29th Floor - Bulletin 3 (engineer) vs Shop Drawing SD R2 (1/2)

Left: Bulletin 3 M-529, cloud shown dashed | Right: SD R2 M-529A/B.SD | Q1 = G ceiling linear diffusers replaced | Q2 = perimeter main

Snowflake Fitout - 7 Times Square, Floors 29-31 | Perimeter Linear Diffusers

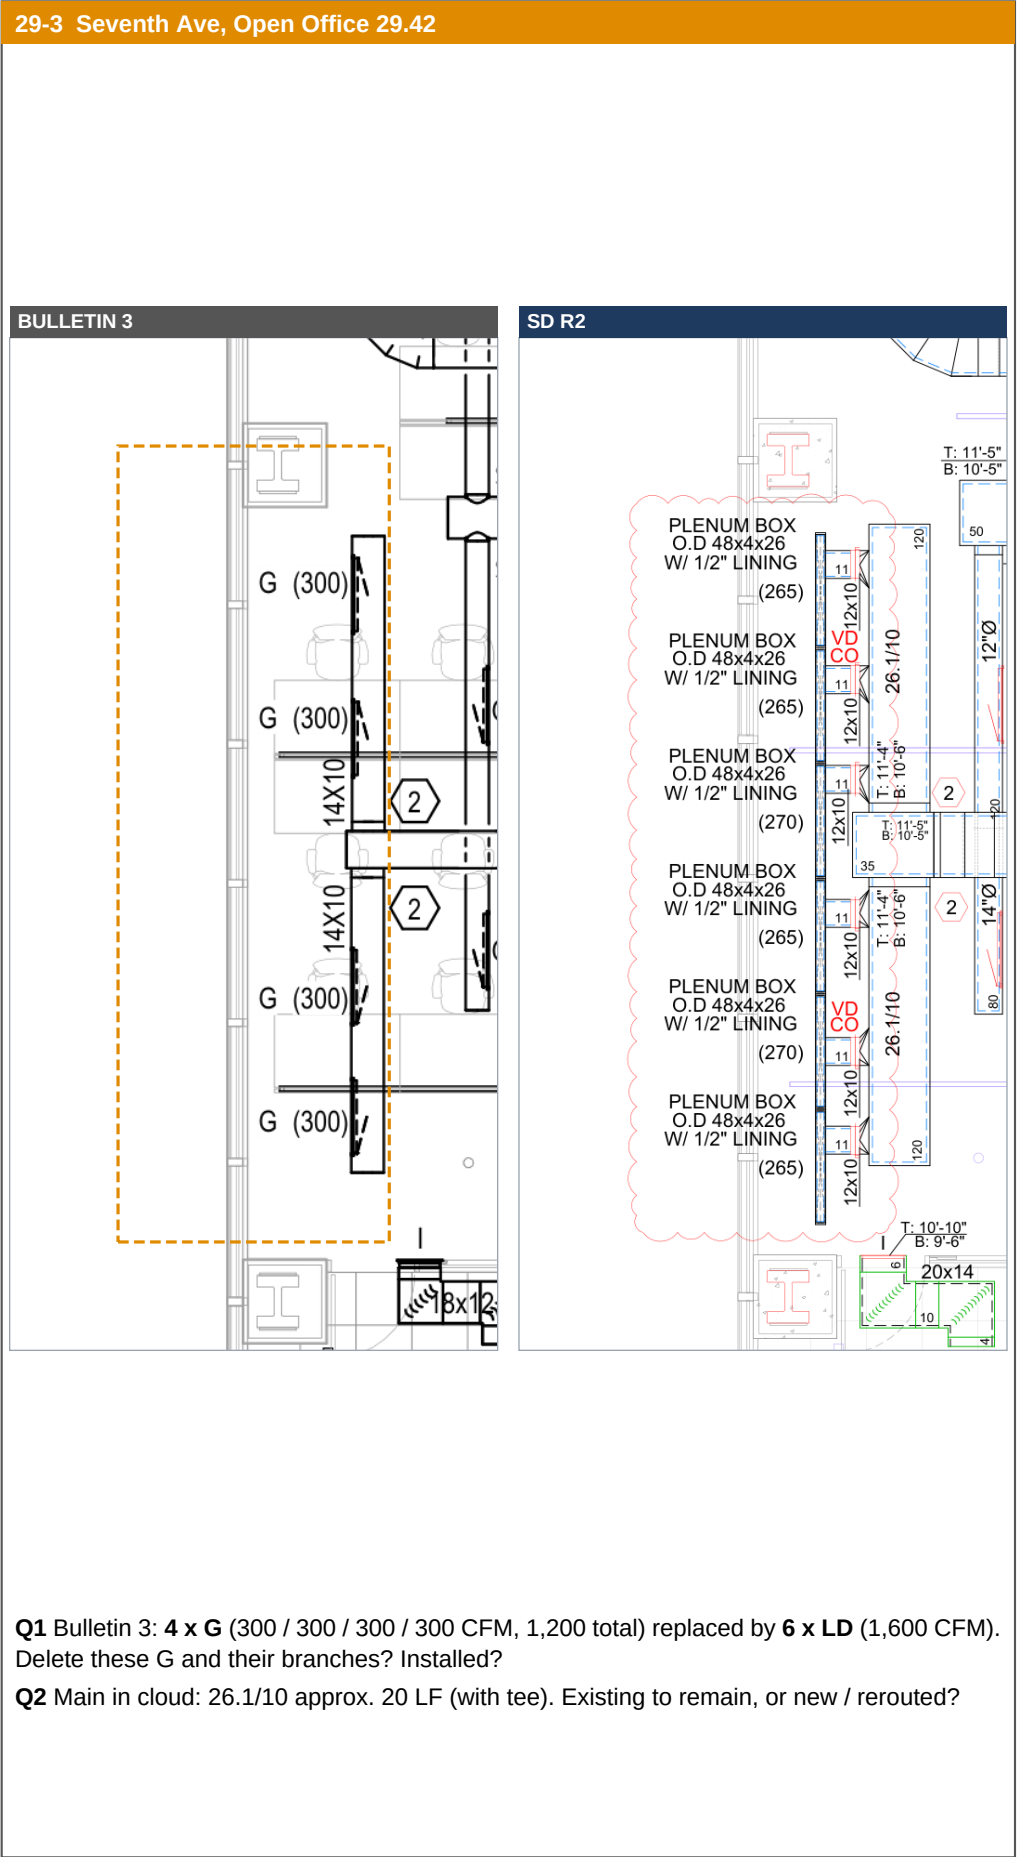
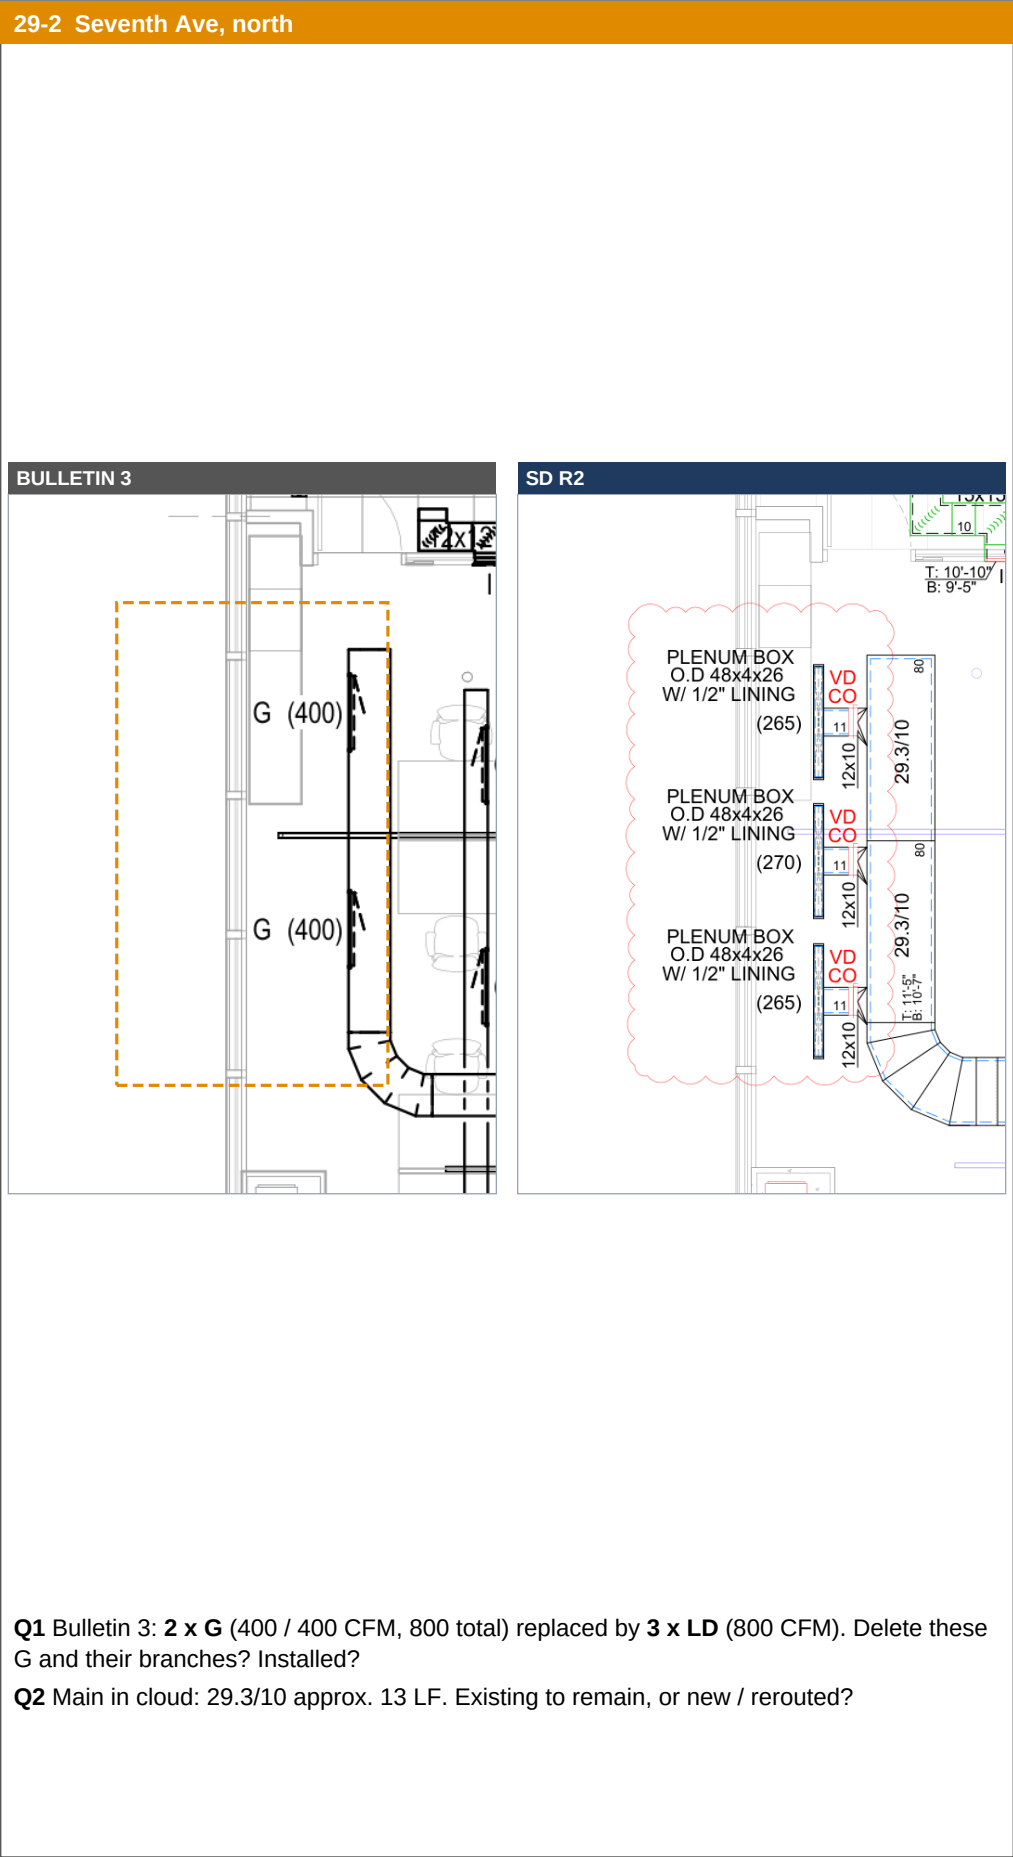
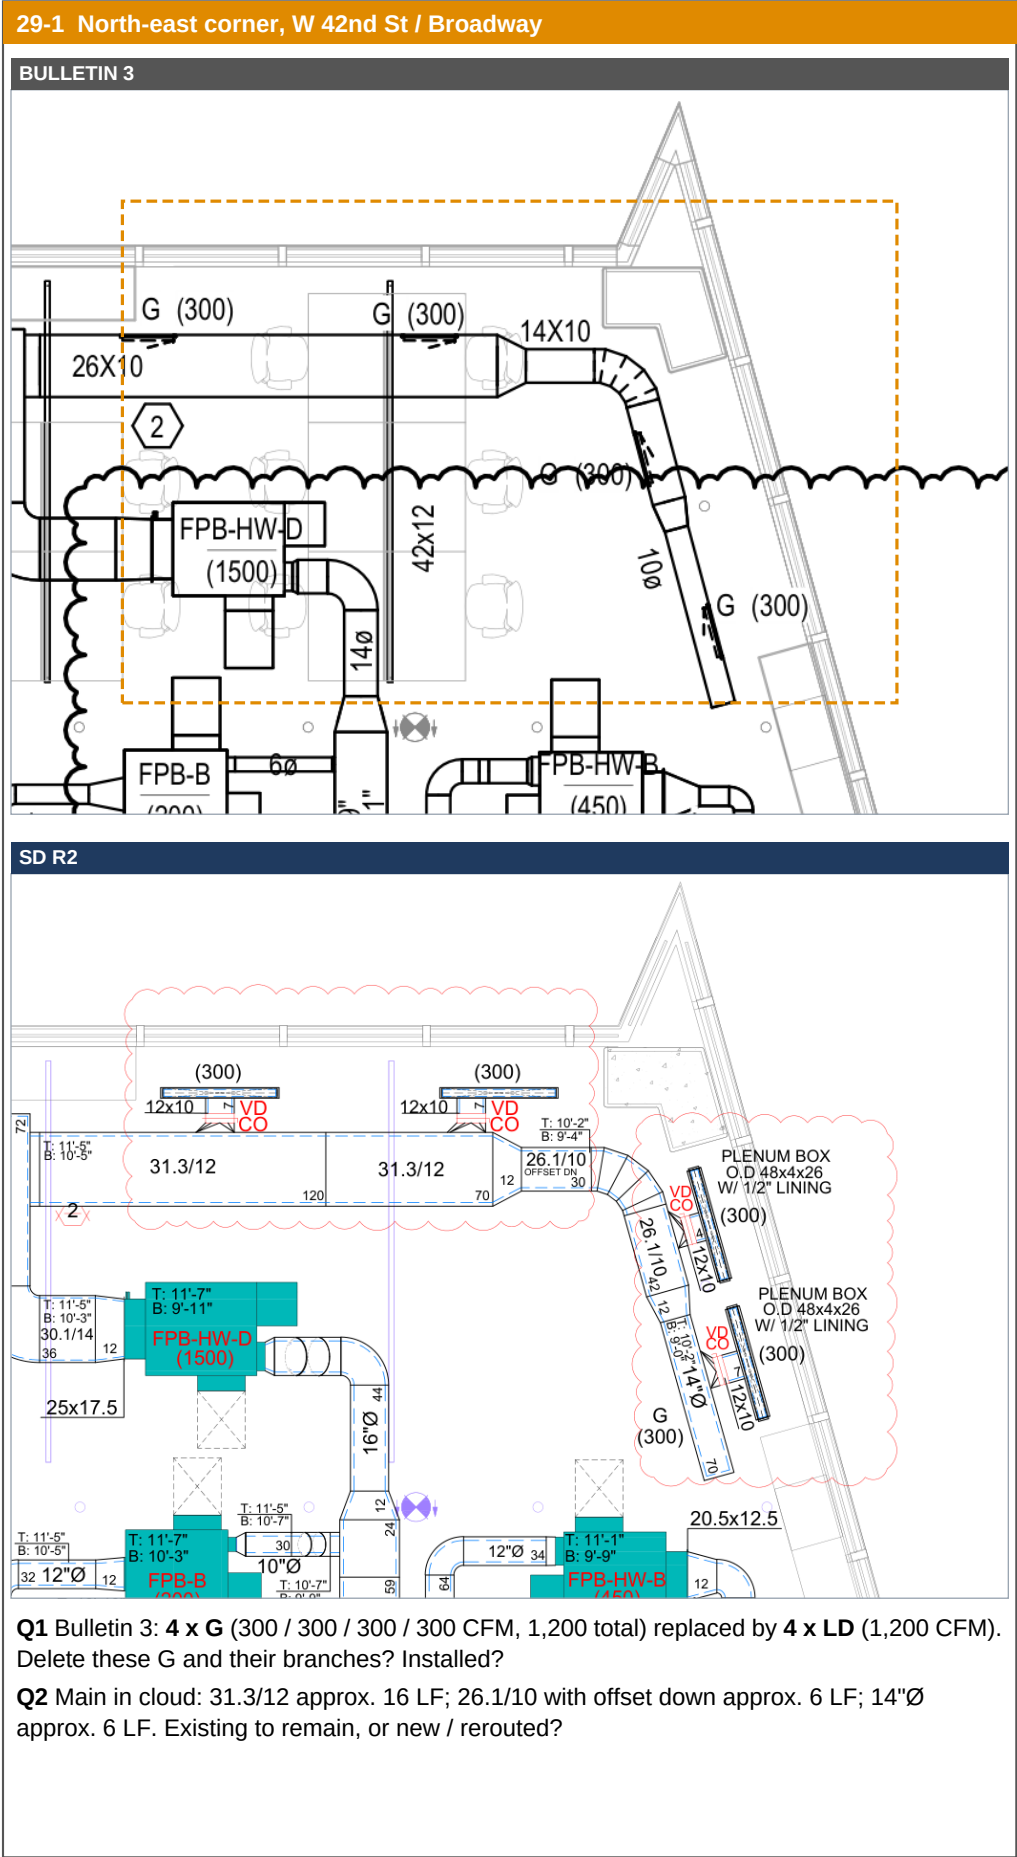
G counts are the Bulletin 3 diffuser tags inside each cloud (mapped from the shop drawing); each tag is counted once. The perimeter G diffusers in Bulletin 3 sit in the ceiling set in from the window; the SD R2 LDs sit at the window wall in plenum boxes, so the G ceiling diffusers, their branch duct and flex would be deleted.

Please confirm per area: (1) delete the G diffusers and their branches, and whether any are already installed (removal) or only furnished (credit / restock); (2) whether the perimeter main shown in the cloud is existing to remain with new taps only.

29-4 Broadway, north

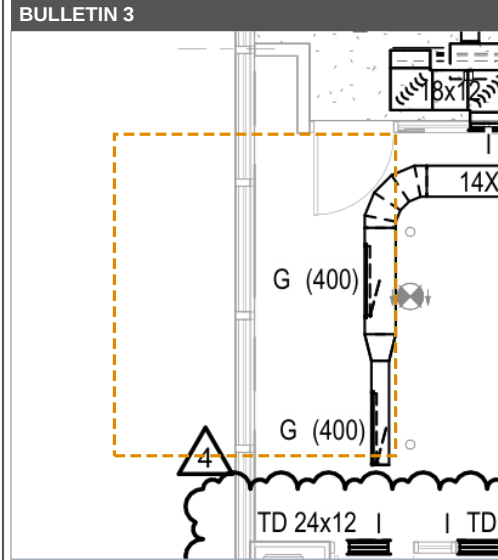
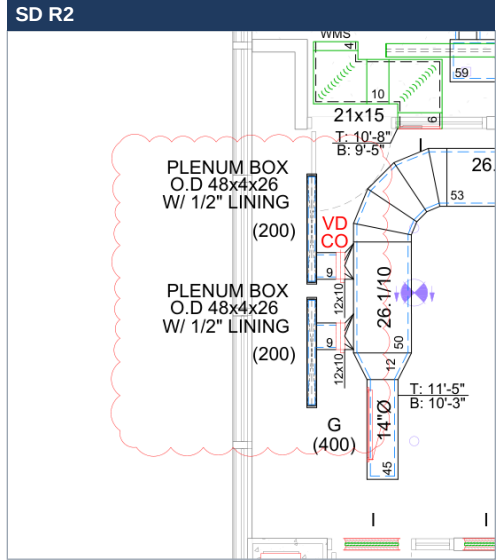
Q1 Bulletin 3: **1 x G** (400 CFM, 400 total) replaced by **2 x LD** (400 CFM). Delete these G and their branches? Installed?

Q2 Main in cloud: 34.4/12 approx. 8 LF. Existing to remain, or new / rerouted?

29-5 Seventh Ave, south (north end of sheet B)

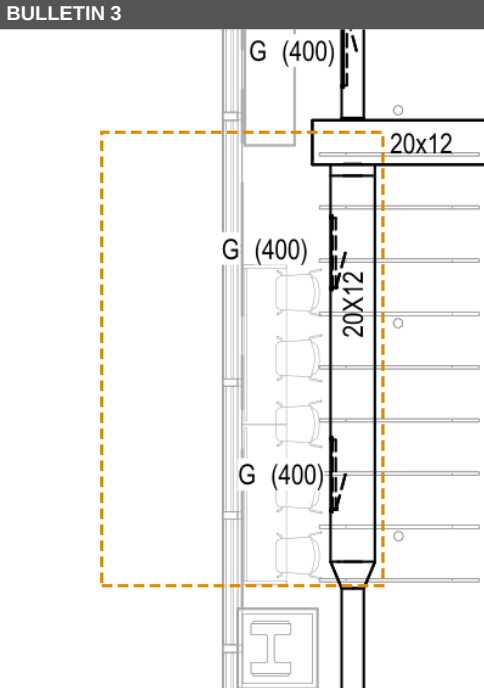
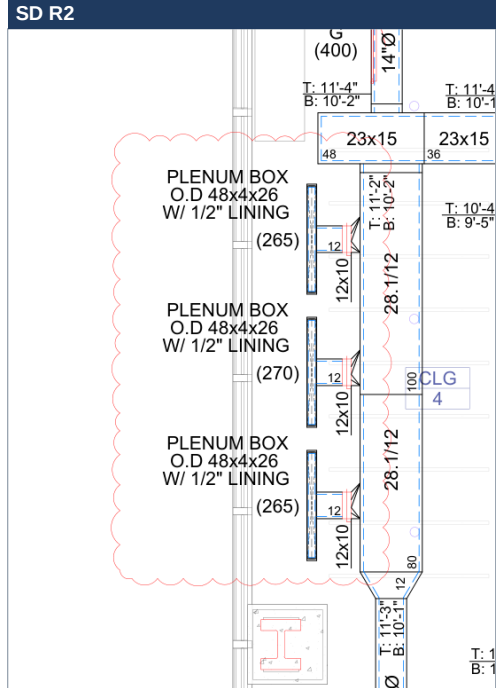
Q1 Bulletin 3: **3 x G** (400 / 400 / 400 CFM, 1,200 total) replaced by **4 x LD** (1,200 CFM). Delete these G and their branches? Installed?

Q2 Main in cloud: 31.3/12 approx. 12 LF; 14"Ø approx. 8 LF. Existing to remain, or new / rerouted?

30-3 South wall (W 41st St side)

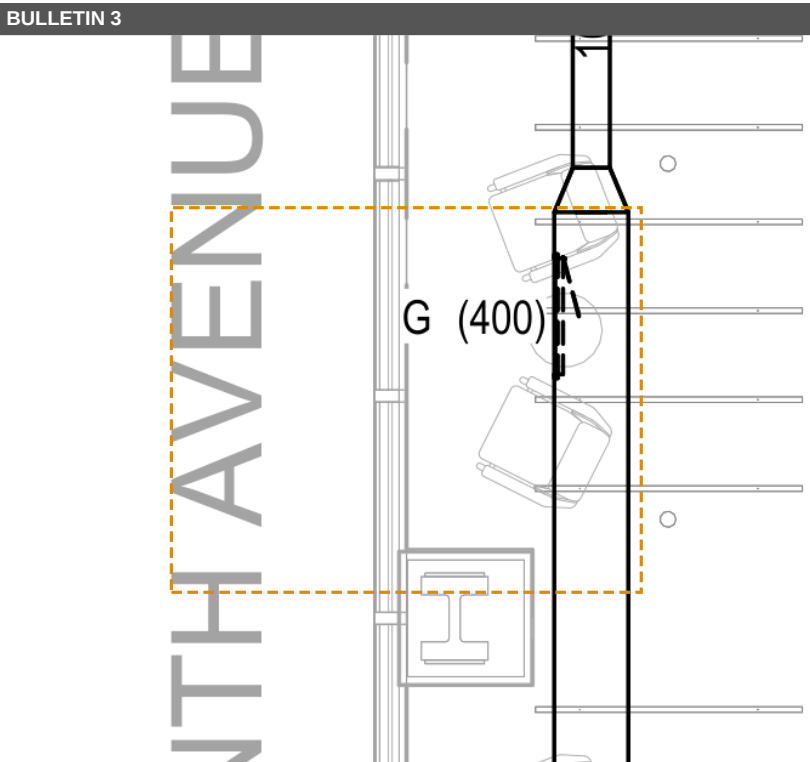
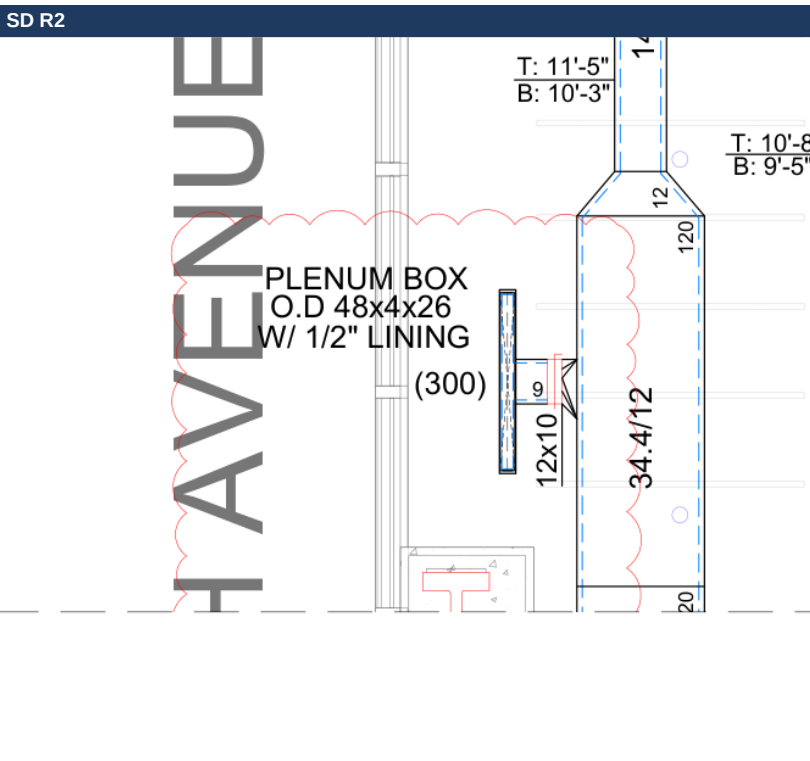
Q1 Bulletin 3: **3 x G** (400 / 400 / 400 CFM, 1,200 total) replaced by **4 x LD** (1,200 CFM). Delete these G and their branches? Installed?

Q2 Main in cloud: 32.2/16 approx. 40 LF. Existing to remain, or new / rerouted?

31-4 Seventh Ave, 7P Meeting Rm 31.43

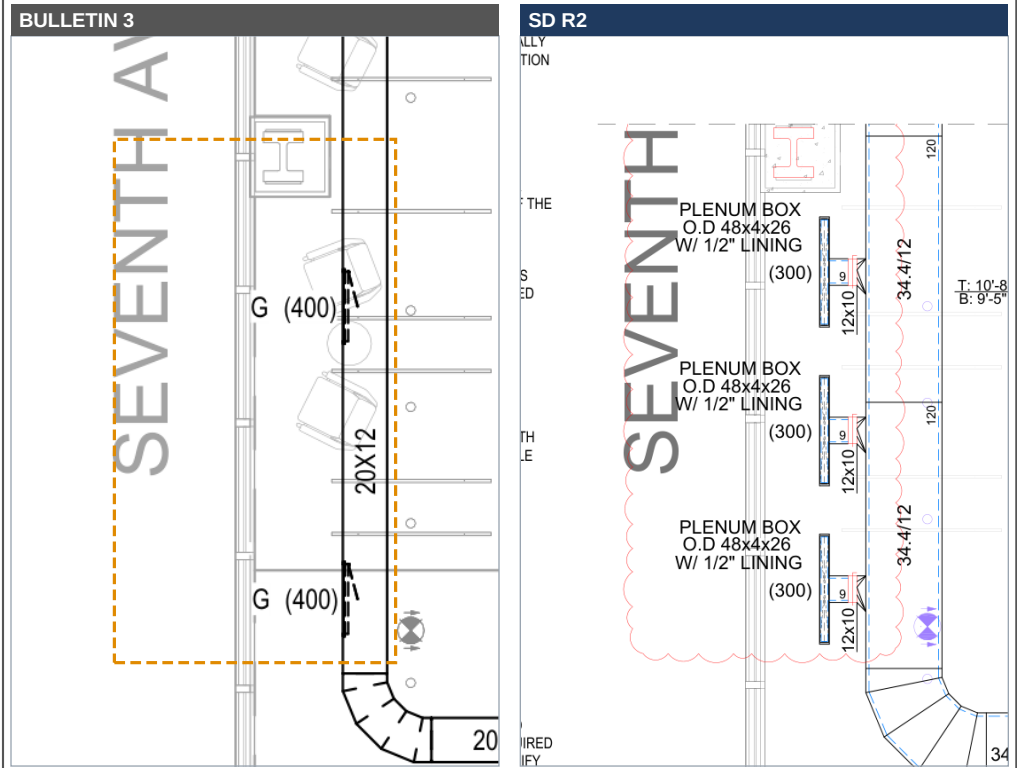
Q1 Bulletin 3: **2 x G** (400 / 400 CFM, 800 total) replaced by **3 x LD** (900 CFM). Delete these G and their branches? Installed?

Q2 Main in cloud: 34.4/12 approx. 20 LF. Existing to remain, or new / rerouted?

31-5 Seventh Ave, south

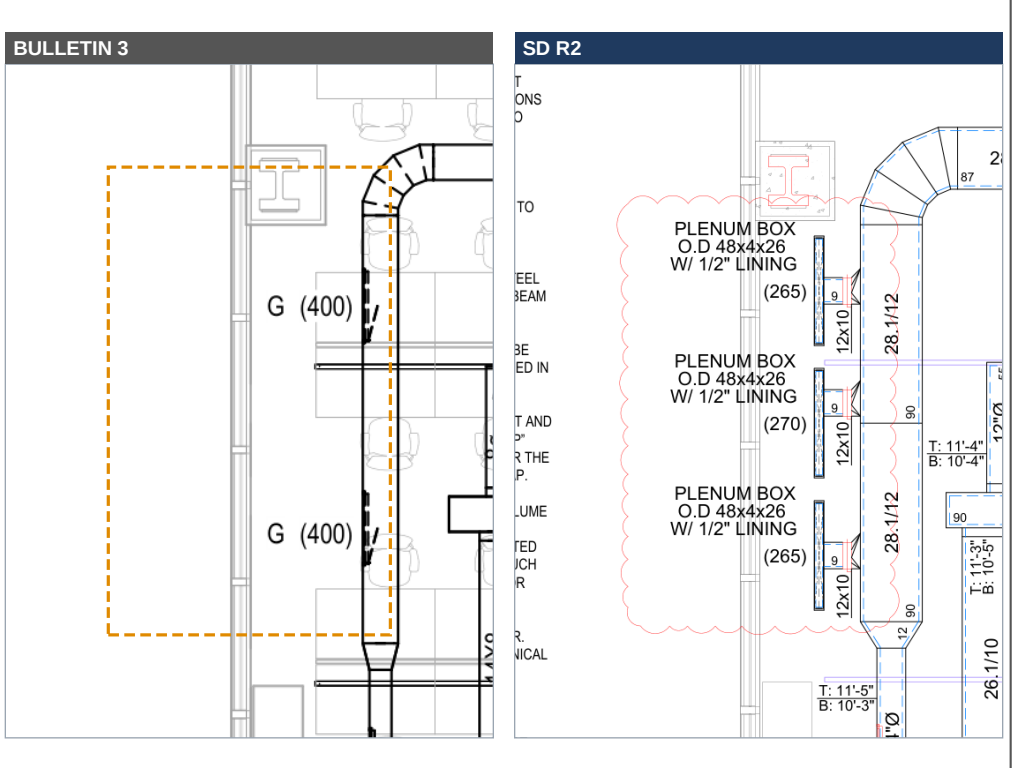
Q1 Bulletin 3: **2 x G** (400 / 400 CFM, 800 total) replaced by **3 x LD** (800 CFM). Delete these G and their branches? Installed?

Q2 Main in cloud: 28.1/12 approx. 15 LF. Existing to remain, or new / rerouted?

31-6 Broadway, south

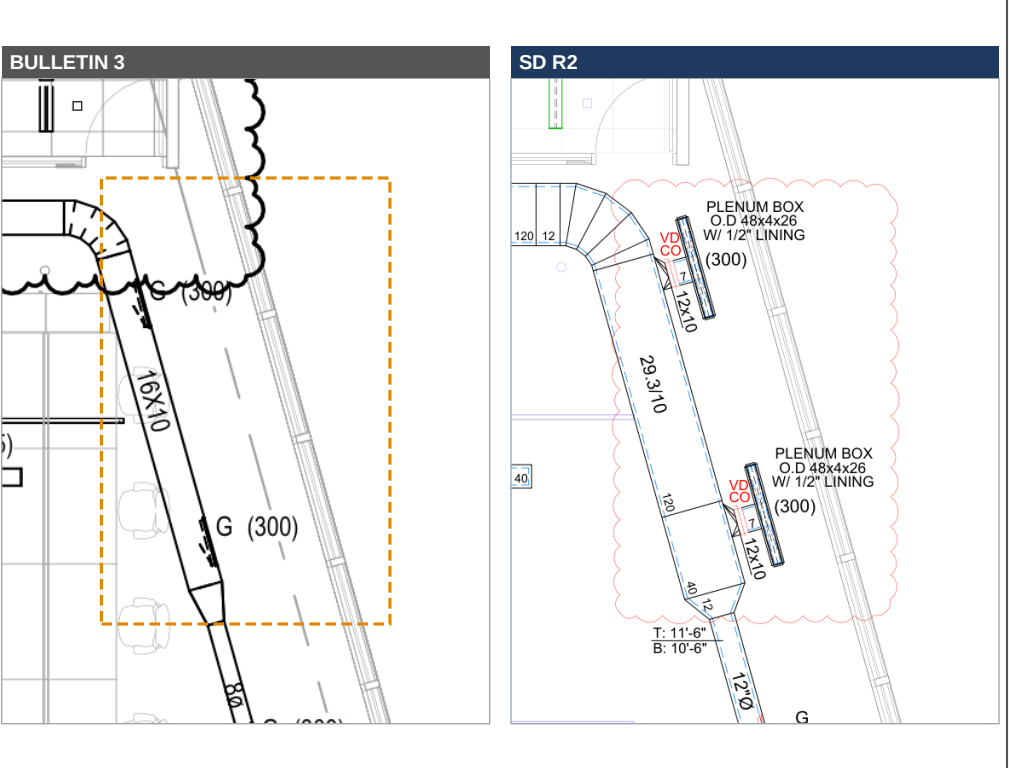
Q1 Bulletin 3: **2 x G** (300 / 300 CFM, 600 total) replaced by **2 x LD** (600 CFM). Delete these G and their branches? Installed?

Q2 Main in cloud: 29.3/10 approx. 13 LF. Existing to remain, or new / rerouted?
